Appl. No. 09/844,840
Amdt. Dated July 30, 2004
Reply to Office Action of April 30, 2004

Appl. No. 09/844,840
Amdt. Dated July 30, 2004
Reply to Office action of April 30, 2004
Annotated Sheet Showing Changes

FIG. 1

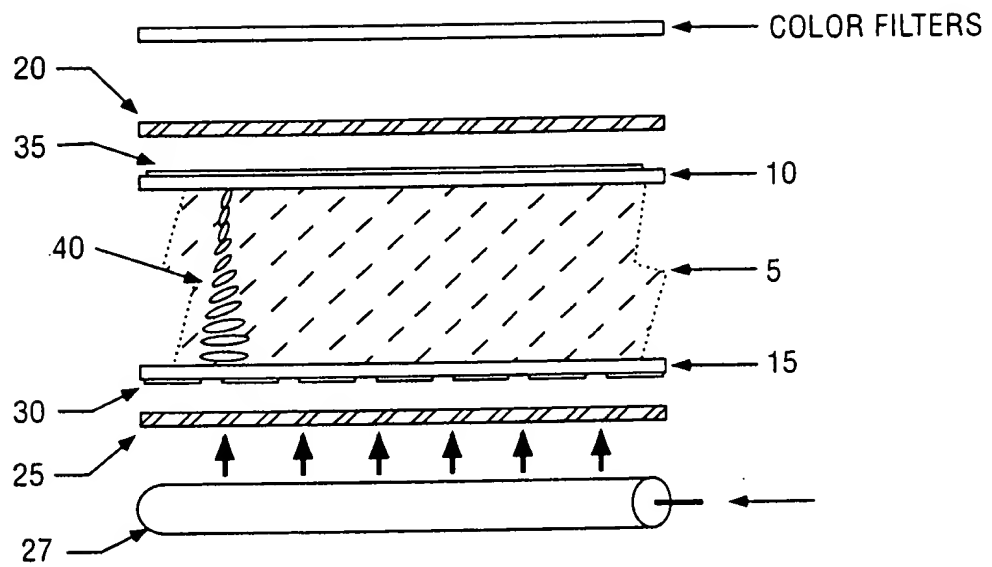
The drawings were objected to under 37 C.F.R. §1.83(a). Figures 1 and 4 have been amended. In particular, Figure 1 has been amended to include the designation legend "Prior Art". Moreover, Figure 4 has been amended to illustrate synchronizer (95) including a digital timer connected to a voltage controller as requested by the Examiner. Support for this limitation can be found on page 6, lines 13-14 of the subject application. No new matter has been added.
